SERVICE TIPS

82-16

GAME: POWER SUPPLY #08-00007-001 USED ON "QIX", ALPINE SKI, WILD WESTERN,
KRAM, ELECTRIC YO YO.

SUBJECT: BR1 AND BR2 HEATING UP TO THE EXTENT OF BREAKING DOWN INTERNALLY.

FIGURE 1

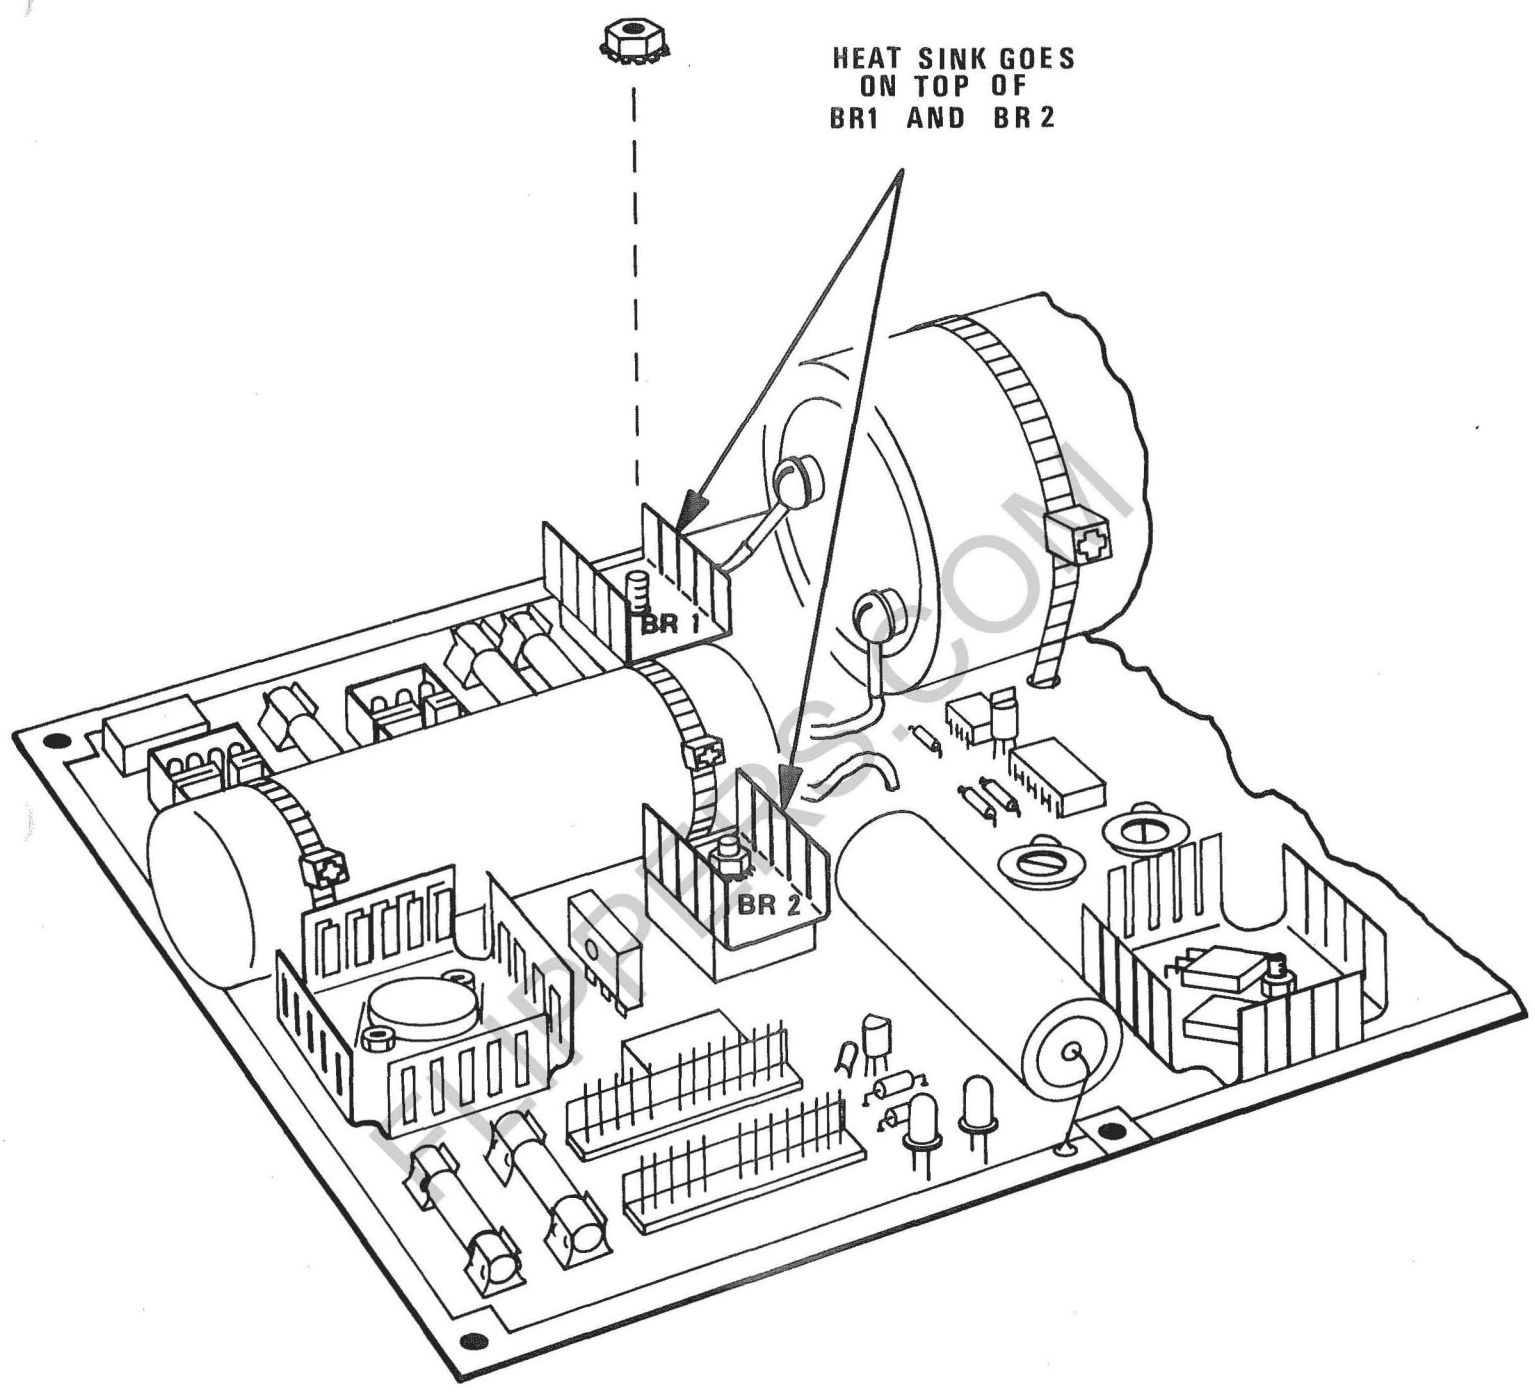
HEAT SINK GOES
ON TOP OF
BR1 AND BR 2

SOLUTION: ADDING HEAT SINKS ONTO BR1 AND BR2.

PROCEDURE: POWER DOWN GAME, REMOVE POWER SUPPLY P.C.B. 08-00007-001
APPLY HEAT SINK COMPOUND TO THE TOP OF BR1 AND BR2 (REFER
TO FIGURE 1). PLACE A HEAT SINK ON TOP OF BR1 ALIGNING HOLES
AND MAKING SURE THAT HEAT SINK DOESN'T TOUCH ANY OTHER
COMPONENTS. FEED THE SCREW THROUGH THE ETCH SIDE OF THE
POWER SUPPLY. TIGHTEN THE NUT SNUGGLY. REPEAT PROCEDURE
FOR BR2.

FIGURE 1

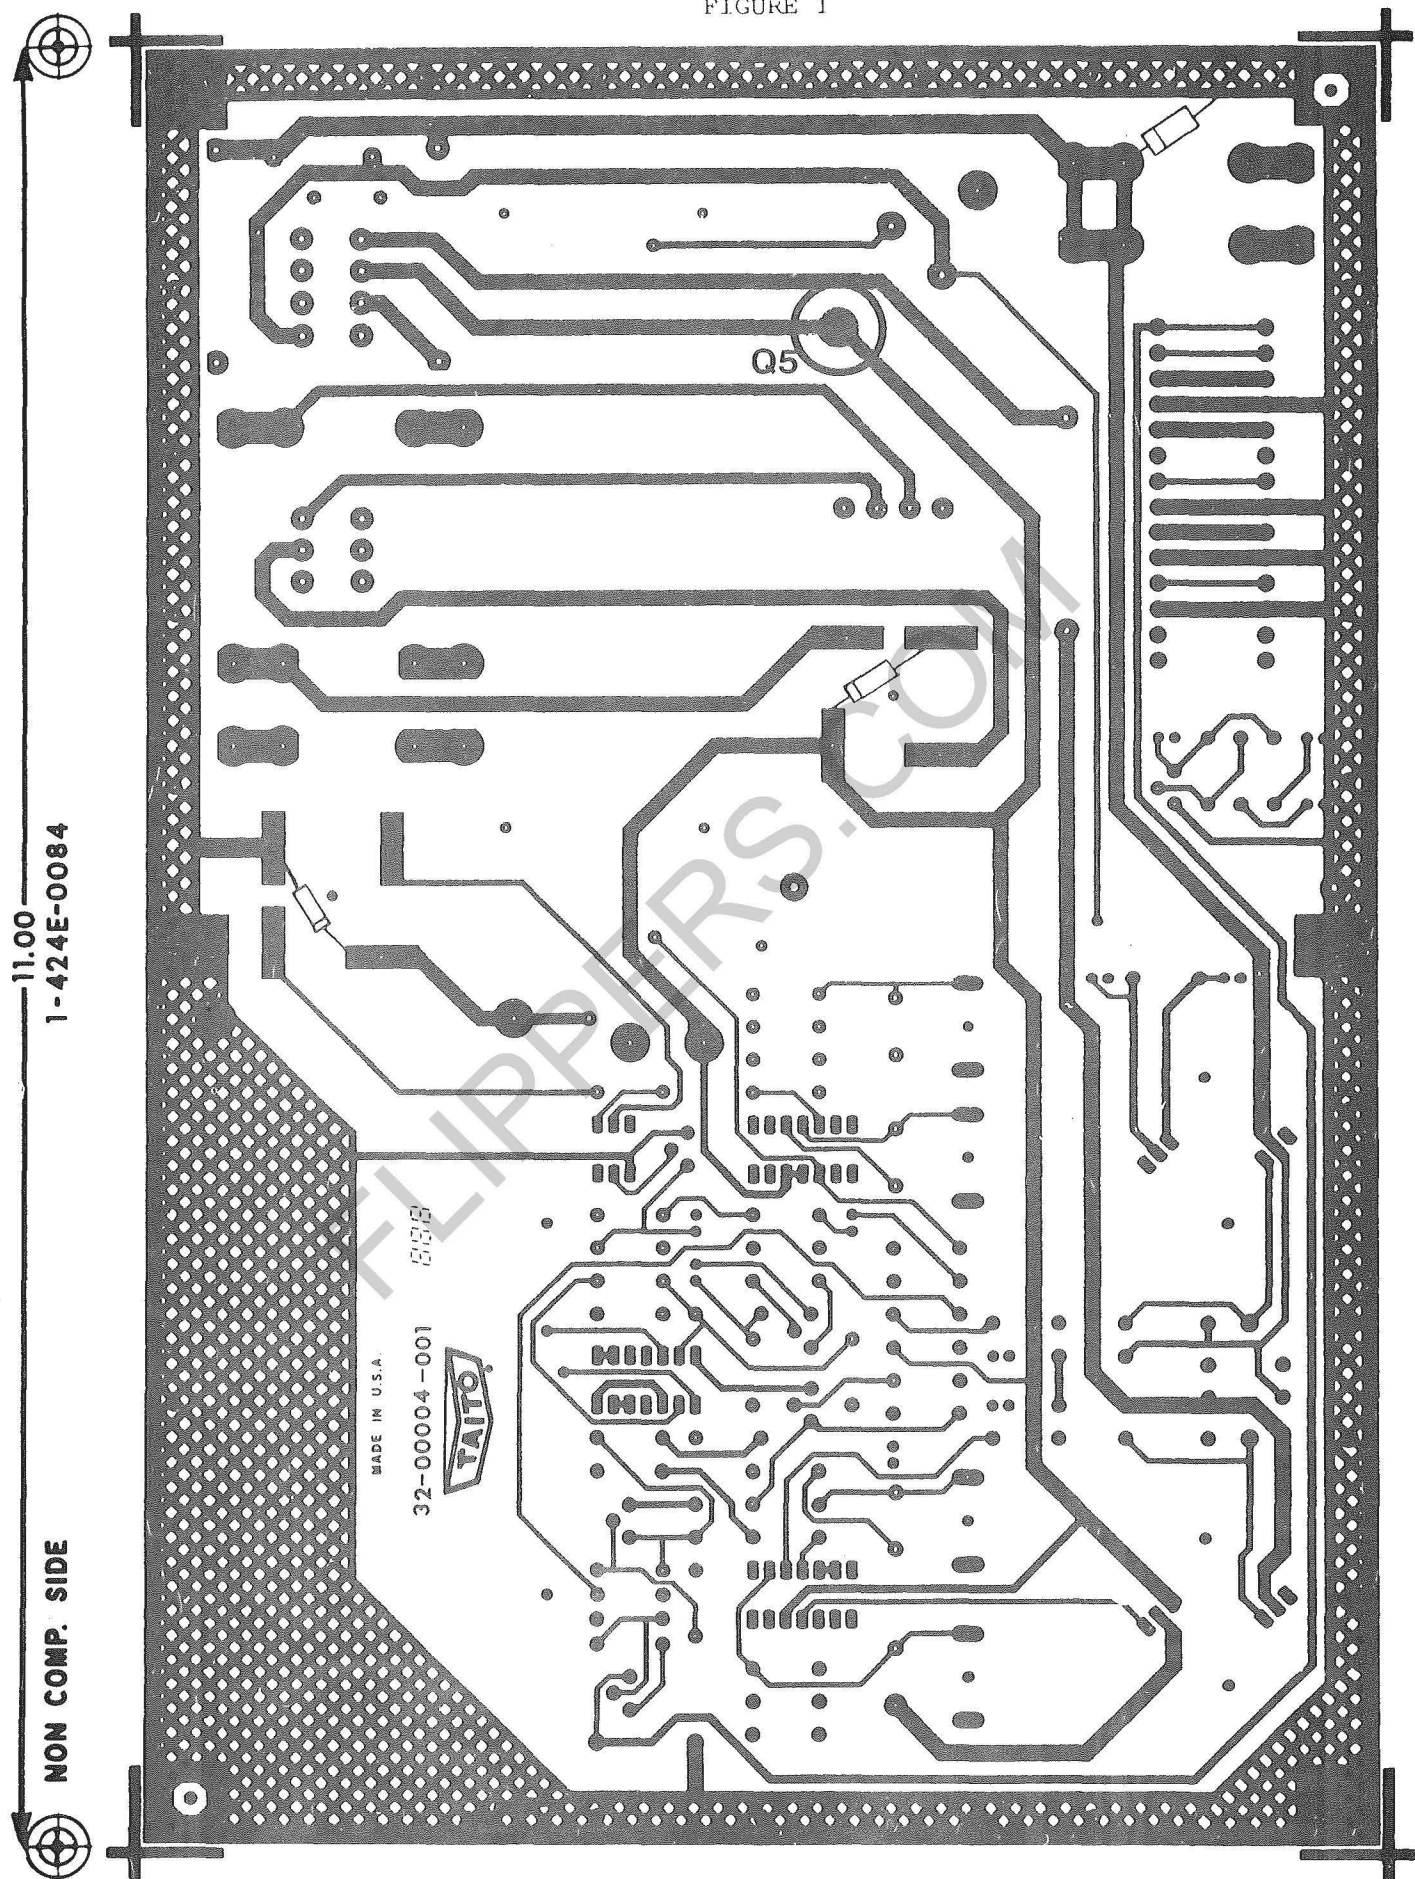
SUBJECT: POWER SUPPLY +5 VOLT PROBLEMS

SOLUTION: IMPROVE Q5'S CONNECTION ON POWER SUPPLY

PROCEDURE: REMOVE THE TWO NUTS AND BOLTS HOLDING DOWN Q5. ON THE ETCH
SIDE OF THE BOARD (REFER TO FIGURE 1), SCRAPE THE GREEN SOLDER
RESIST OVER THE FOIL AROUND THE SCREW PAD FOR Q5. WET THE
PAD WITH SOLDER TO MAKE SURE THAT ALL SOLDER RESIST MATERIAL
IS REMOVED. REPLACE NUTS AND BOLTS FOR Q5.

FIGURE 1

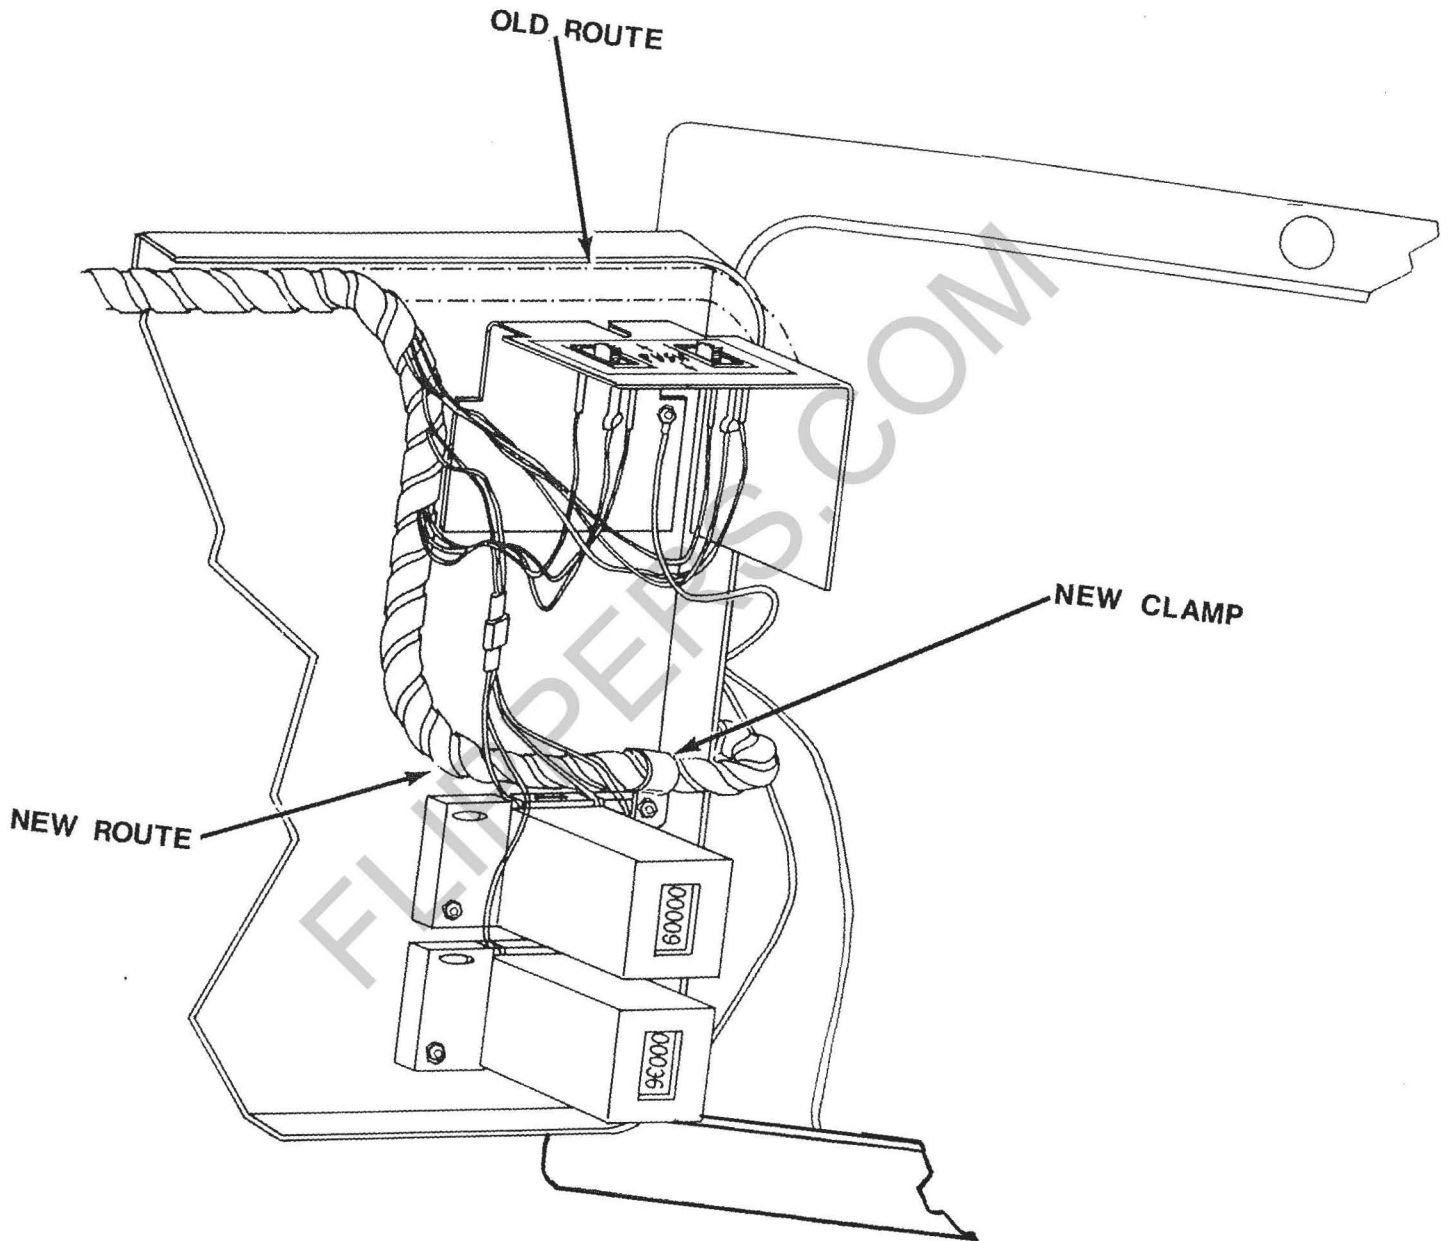
SUBJECT: COIN DOOR CABLE CAN GET PINCHED IN COIN DOOR FRAME.

2. RE-ROUTE CABLE ON COIN DOOR AS FOLLOWS: (SEE FIG. 1)

- A. SNIP WIRE TIE THAT HOLDS FLEXIBLE CABLE TO COIN DOOR (ABOVE SERVICE SWITCH BRACKET).

- B. RE-ROUTE CABLE TO THE LEFT OF AND UNDER THE SERVICE SWITCH BRACKET.
 - C. REMOVE UPPER RIGHT NUT FROM THE TOP COIN COUNTER.
 - D. REINSTALL NUT TRAPPING SMALL CABLE CLAMP (59-00004-004) AROUND COIN DOOR CABLE ON COIN COUNTER SO THE CABLE IS NOW POSITIONED HALF-WAY DOWN THE COIN DOOR HINGE.
3. REINSTALL CABLES AS FOLLOWS: (SEE FIG. 2)
- A. REMOVE LOWER RIGHT SCREW ON INTERLOCK ASSEMBLY COVER.
 - B. REINSTALL SCREW, ANCHORING PREVIOUSLY REMOVED CABLE CLAMP AROUND COIN DOOR CABLE.
 - C. RECONNECT MOLDED CONNENCTORS FOR COIN DOOR CABLE.
 - D. VERIFY THAT CABLE FREELY MOVES THROUGH CABLE CLAMP UNDER INTERLOCK ASSEMBLY COVER, TO PREVENT PINCHING THE CABLE.

FIGURE 2

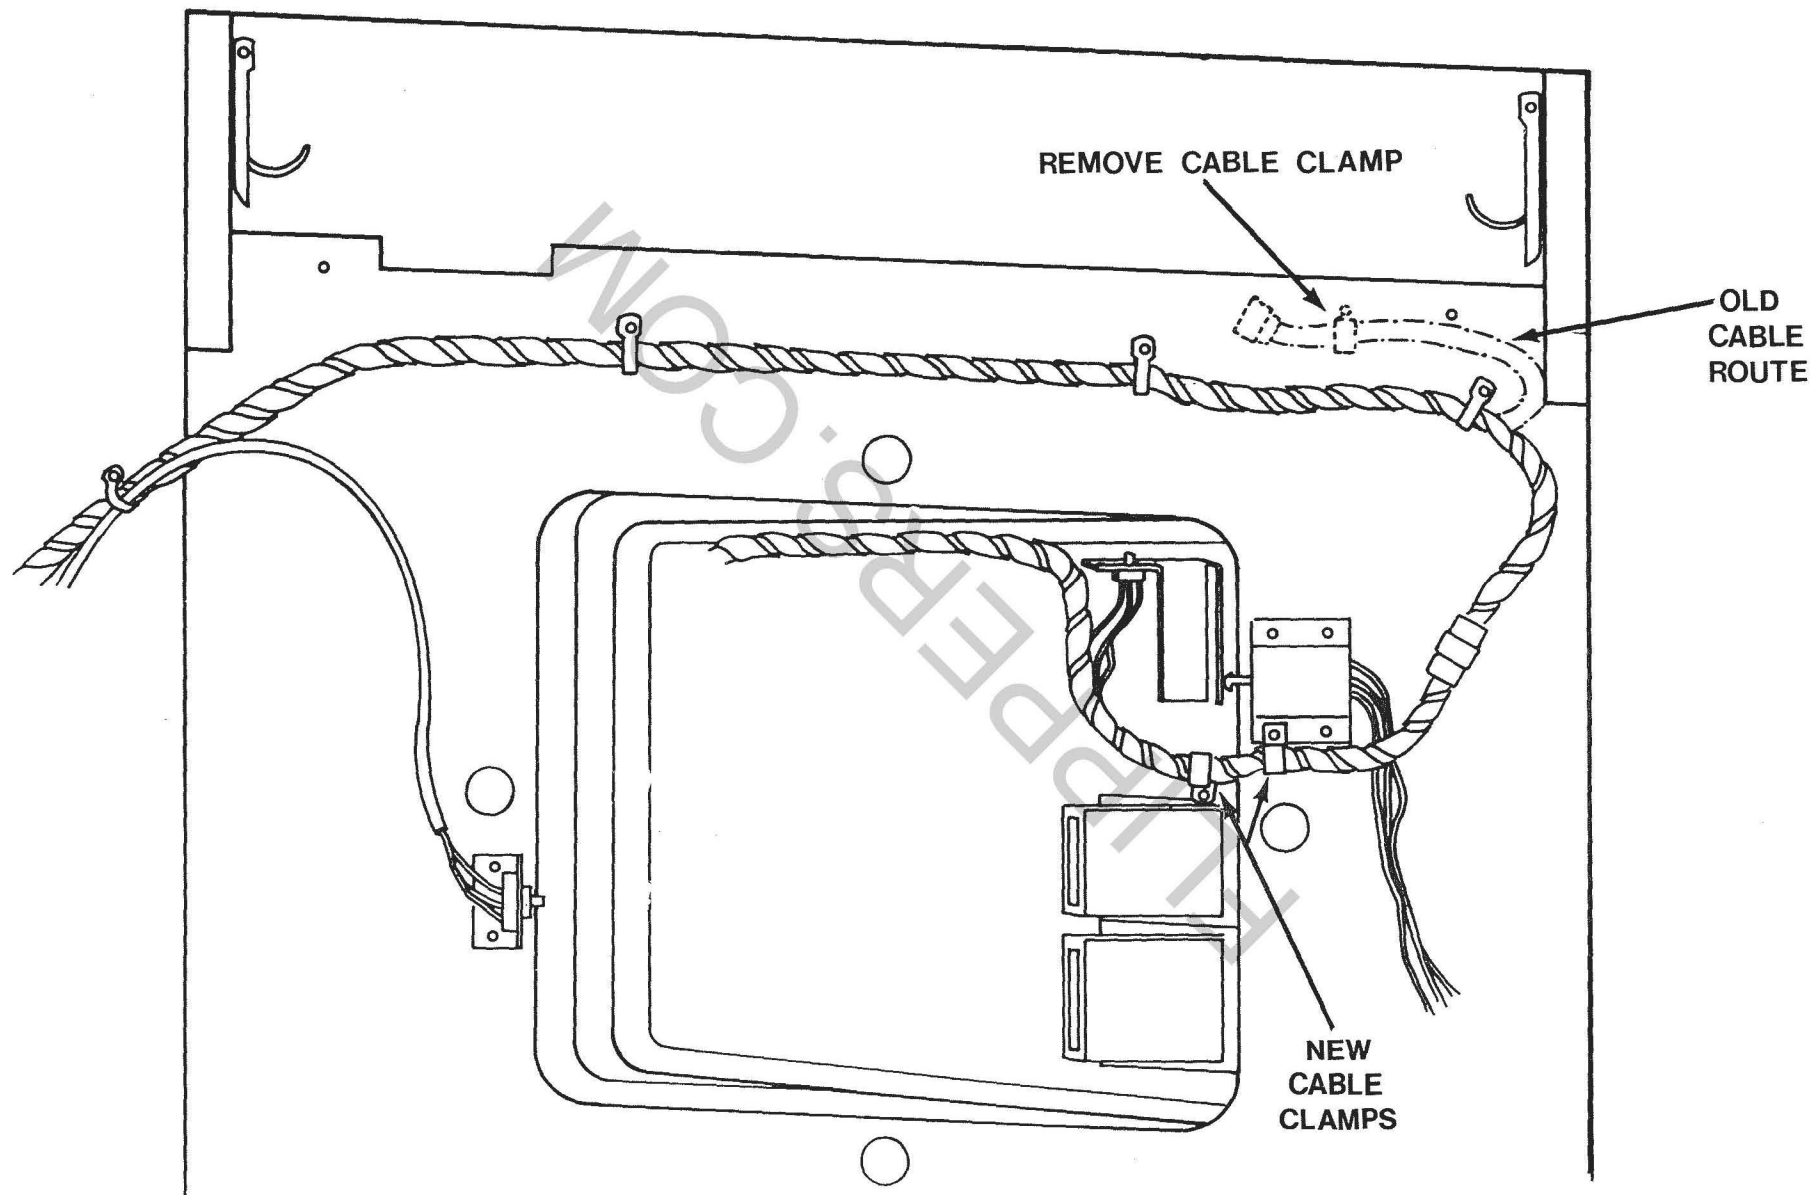
ENSURE THAT THE SCREWS ON C7 AND C9 (REFER TO FIGURE 2) ARE TIGHT. AFTER THE SCREWS ARE TIGHT, MEASURE, WITH THE METER IN AC VOLTAGE MODE, THE OUTPUT OF +5V. THE RIPPLE SHOULD BE LESS THAN A QUARTER OF A VOLT (0.25 V). IF NOT, C7 COULD BE THE PROBLEM.
